Thrive Assisted Living Facility at Black Hill Site Plan No. 820160100

The Applicant is requesting to construct a 140-room assisted living facility, associated parking facility (61 parking spaces), lighting, and landscape on Lot 22 of the Black Hill mixed-use development. The subject property is 2.31 acres of land; developed under the TMX-2 Zone within the Germantown Employment Area Sector Plan.

Staff Recommendations: Approval with Conditions

Staff recommends approval of Site Plan No. 820160100. All site development elements shown on the latest electronic version as of the date of this Staff Report submitted via ePlans to the M-NCPPC are required except as modified by the following conditions.¹

Figure 6 – Amended Project Plan (after)

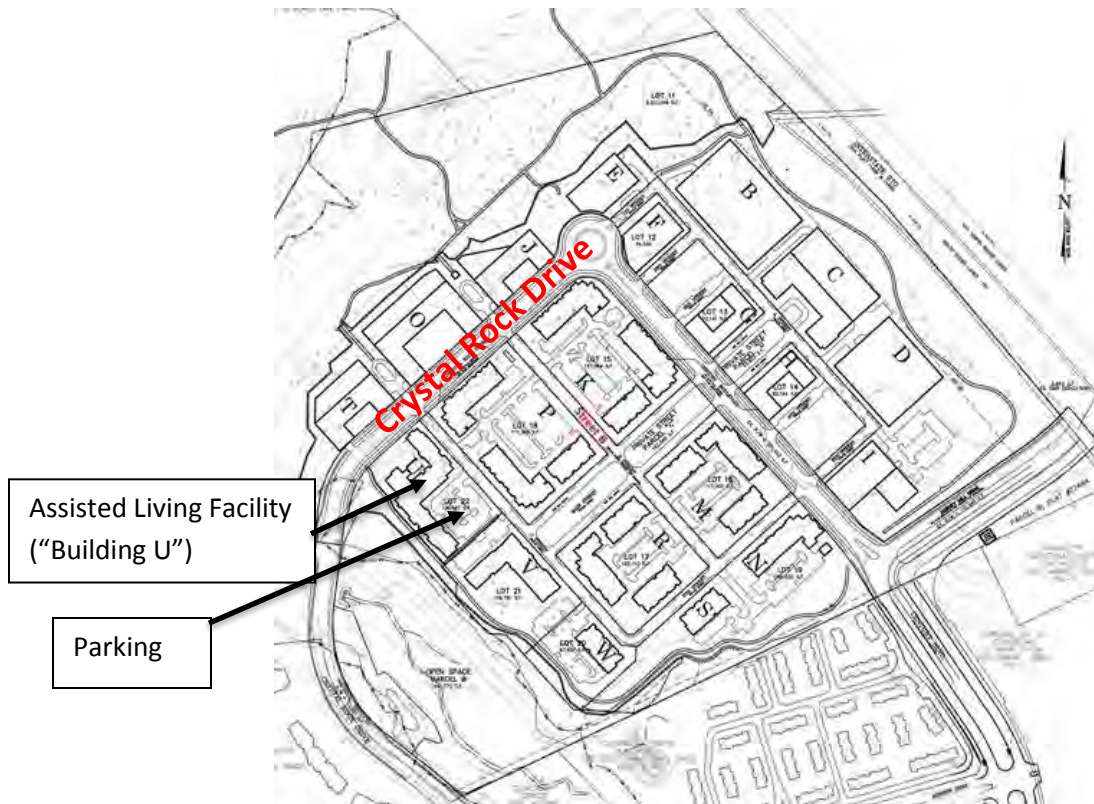
Figure 6 below illustrates the relocation of the building's footprint. The building has shifted to be more consistent the Sector Plan recommendations and to be more engaged with the street's edge (Figure 6 below) and the Sector Plan recommendations. The Sector Plan encourages an urban grid pattern with buildings flanked on either side to frame critical view sheds and create pedestrian oriented streetscapes.

Figure 8 – Employee Open Space Area

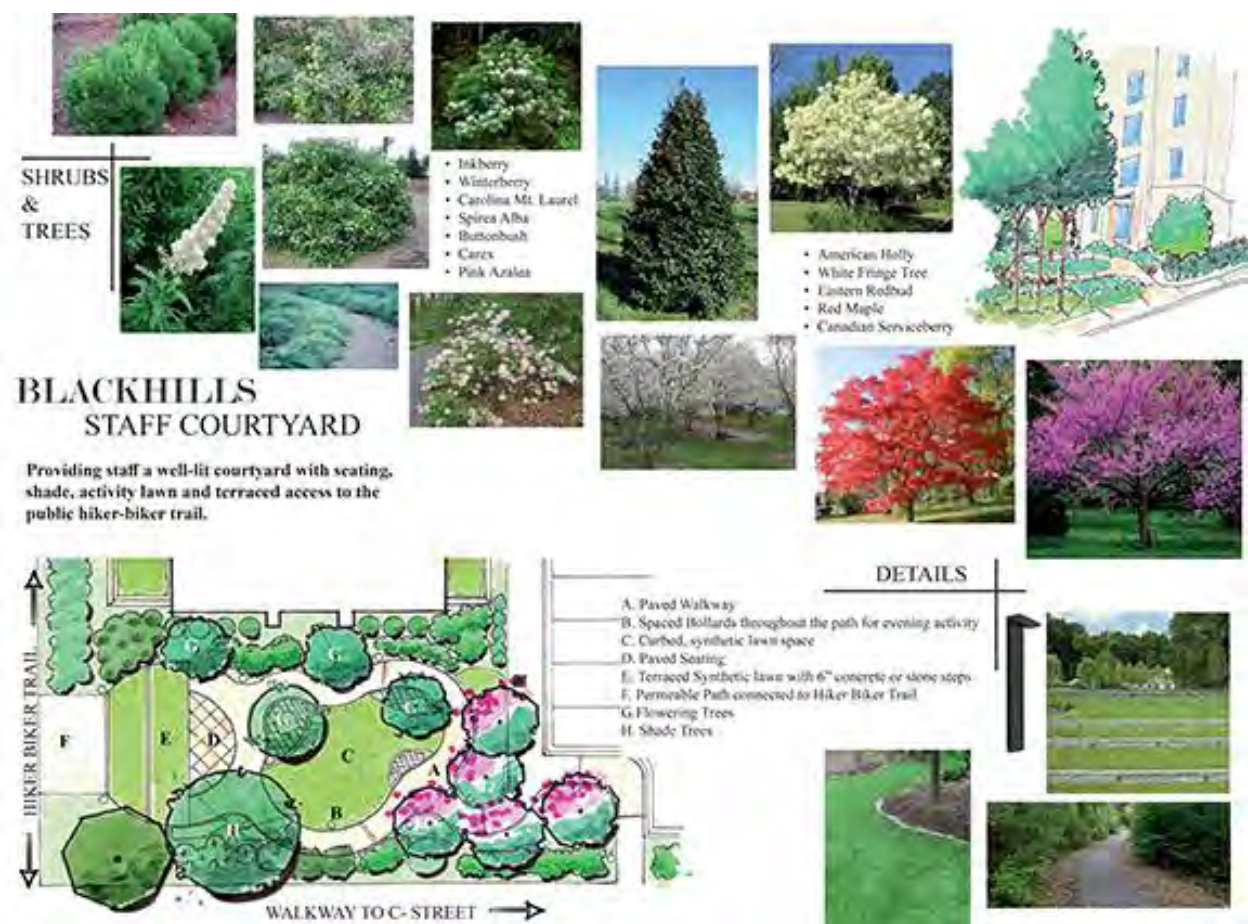
Upon initial review of the building layout, Staff was concerned about the walkability of the streetscape as it relates to building frontage along Balthusrol Drive. Staff has worked with the Applicant to consider several different building design iterations. As a resolution to this issue, the main entrance to the building is oriented toward Baltusrol Drive. Bike racks (5), signage, and planter boxes have also been added along the streetscape to further activate the streetscape. The current layout optimizes the building's efficiency (i.e. required programming within the building), provides scenic views toward the stream valley buffer, and works with the existing grades with minimal disturbance to the stream valley buffer. Staff finds that that the proposed streetscape improvements, considering the limitations of the building's program, are safe and adequate. Therefore, the building layout is efficiently placed on the Subject Property and conforms with the intent of the Sector Plan recommendations.

Figure 13 – Public Use Space (purple) & Circulation Diagram (green & red arrows)

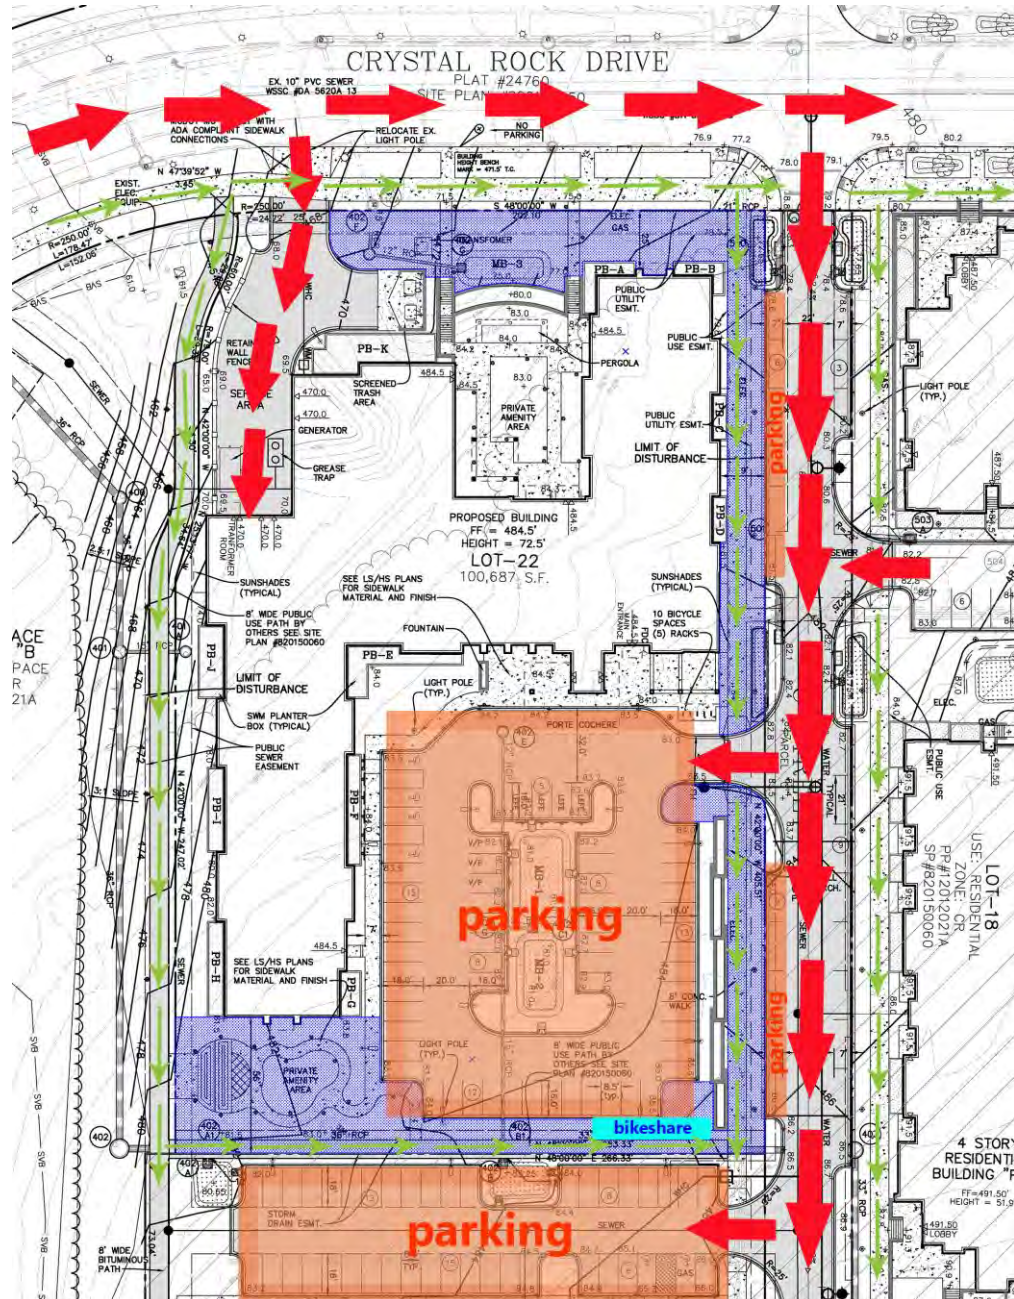
Staff was initially concerned about the placement of the service driveway and dumpsters along the main roadway. However, considering the limitations of the existing slope, building program requirements, and the building orientation, the Applicant is providing adequate screening of “back of house” activities with evergreen plantings, fencing, retaining walls, and trash enclosures. As indicated in Figure 13 below highlighted in blue, the public use space (19%, highlighted in purple below) provided along Baltusrol Drive

and between parking facilities is proposed in addition to the 51% of public use space approved for the entire Black Hill development. Large canopy trees are also located along the streetscape and understory planting help to soften hard edges (i.e. retaining walls and the building) and provide shade and comfort along the pedestrian streetscape.

Figure 15 – Capital Bikeshare Station location

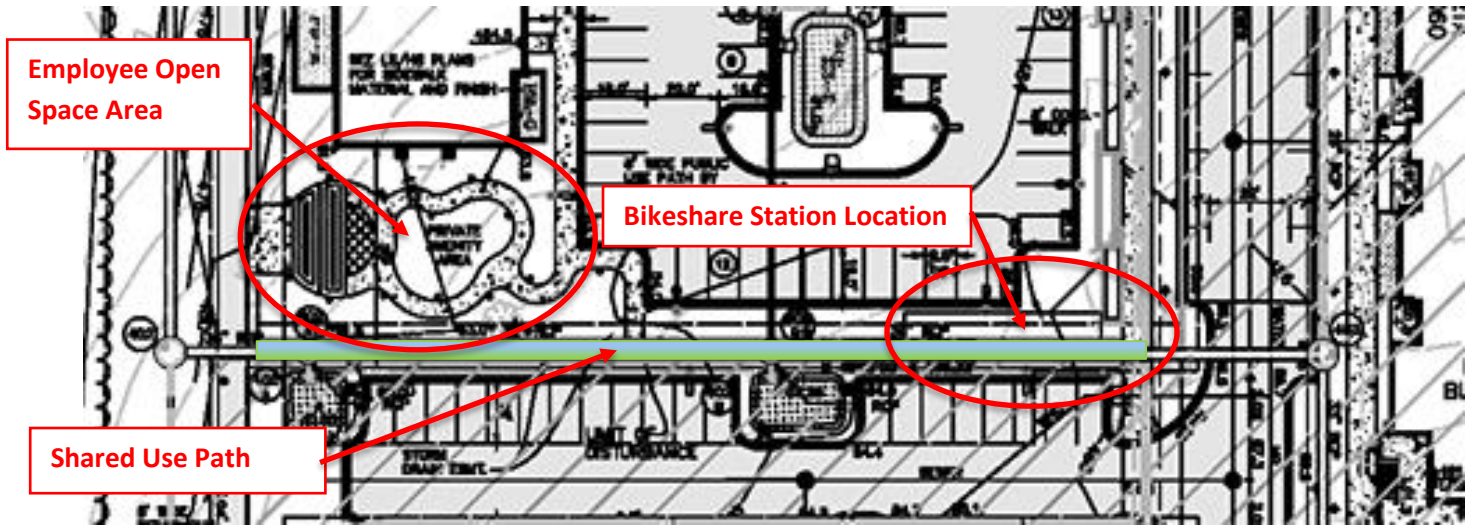
- b) In accordance with the Certified Site Plan, the Applicant will provide a bikeshare station, along Baltusrol Drive (otherwise known as C Street), between the surface parking facilities and in close proximity of the Community Center. The final location of the bikeshare station will be approved by MCDOT and indicated on the Certified Site Plan, based on the requirements of the bikesharing system in a highly visible, convenient and well-lit location on the Subject Property.

Per the conditions of approval, the Applicant is also working closely with the Montgomery County Department of Transportation (MCDOT) to encourage alternative means of transportation for visitors and employees via the Capital Bikeshare program. The Applicant is required to complete a TMAg, which includes the positioning of a bikeshare station (19-dock minimum; approximately 53-feet by 6-feet). As indicated below in Figure 16 below, the bikeshare station will be located directly adjacent to the public shared use path and between the parking facility.

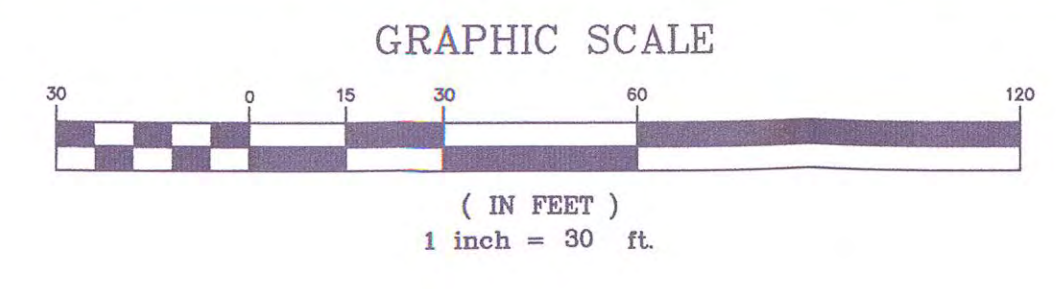
1. Review based only upon information contained on the plan submitted **25-Aug-16**. Review and approval does not cover unsatisfactory installation resulting from errors, omissions, or failure to clearly indicate conditions on this plan.
2. Correction of unsatisfactory installation will be required upon inspection and service of notice of violation to a party responsible for the property.
